Planning Proposal for 'Allfarthing' – 2 Brisbane Grove Rd, Goulburn (REZ/0003/2122) (PP_2021_6932) -Pre-Gateway Referral

ATTACHMENT 1 - DETAIL

Map 1. SLWCA Unsewered Residential development (lots 4,000 m² to 2 ha) for 'Allfarthing', 2 Brisbane Grove Rd Goulburn

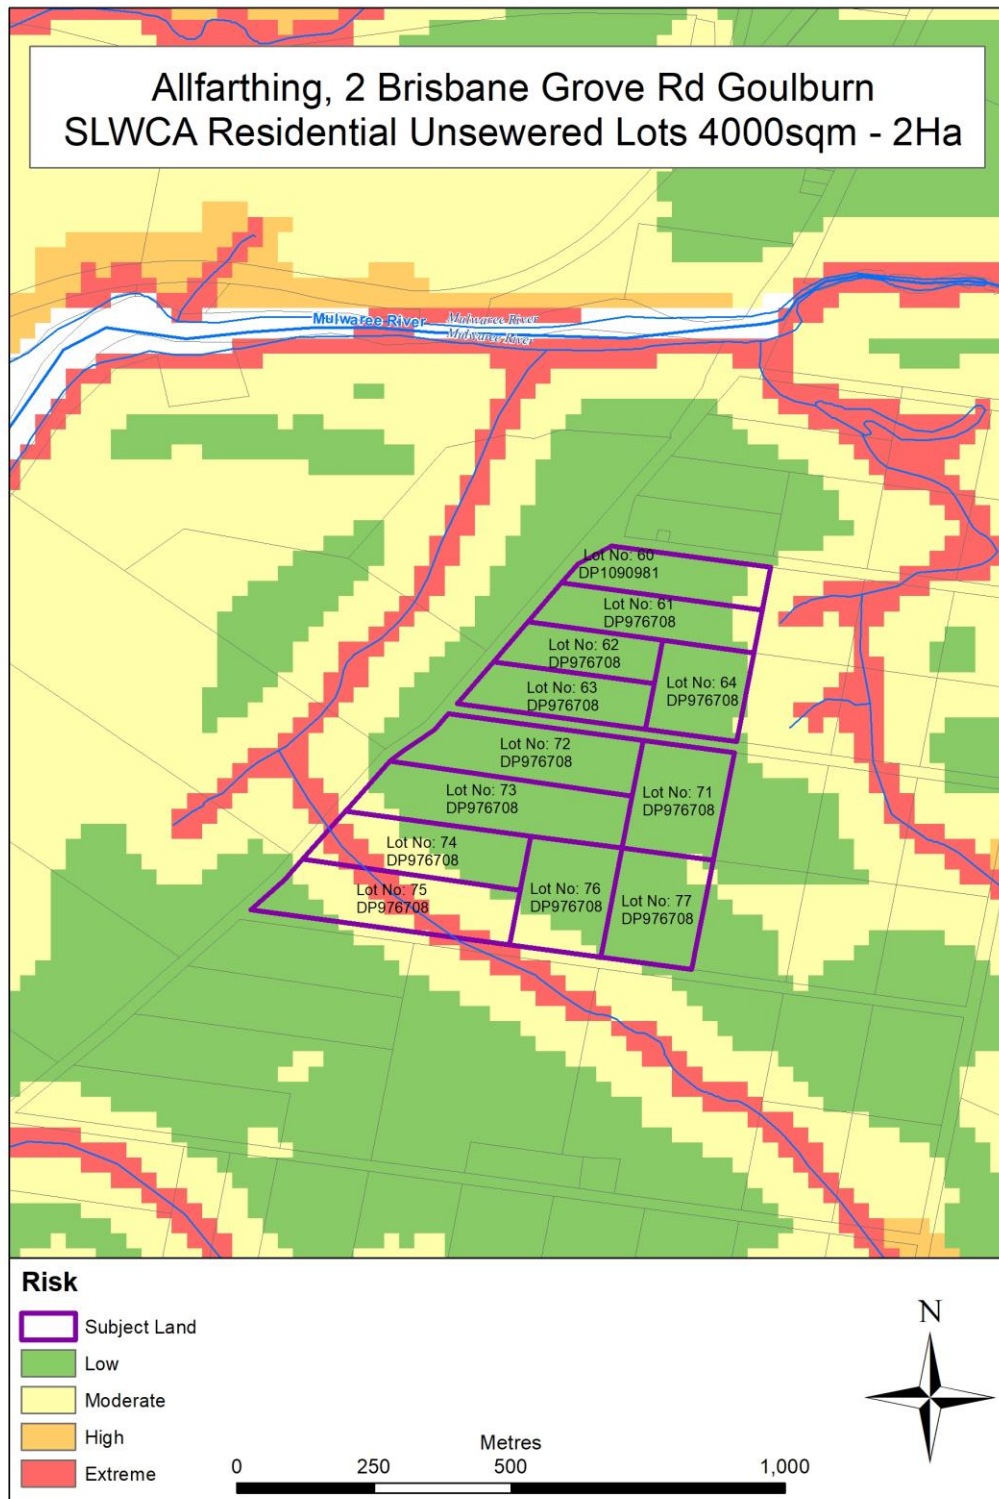
WaterNSW has prepared a Strategic Land and Water Capability Assessment (SLWCA) for the site. The most applicable SLWCA is for unsewered residential lots (4,000 sqm – 2 ha). The outcomes of the SLWCA is presented in Attachment 2. The SLWCA shows that the water quality risk to the site varies from LOW to EXTREME. The areas classified as EXTREME are associated with the watercourse affecting land in the south-west corner of the site. Most of the northern area of the site carries a LOW water quality risk. Areas of LOW risk generally have a HIGH capability for unsewered development while areas of EXTREME risk have a VERY LOW capability. We encourage unsewered development to be located in areas of LOW to MODERATE risk.

Please note that the variables influencing the outputs of the SLWCAs include distance to water courses, but do not include flooding risk.
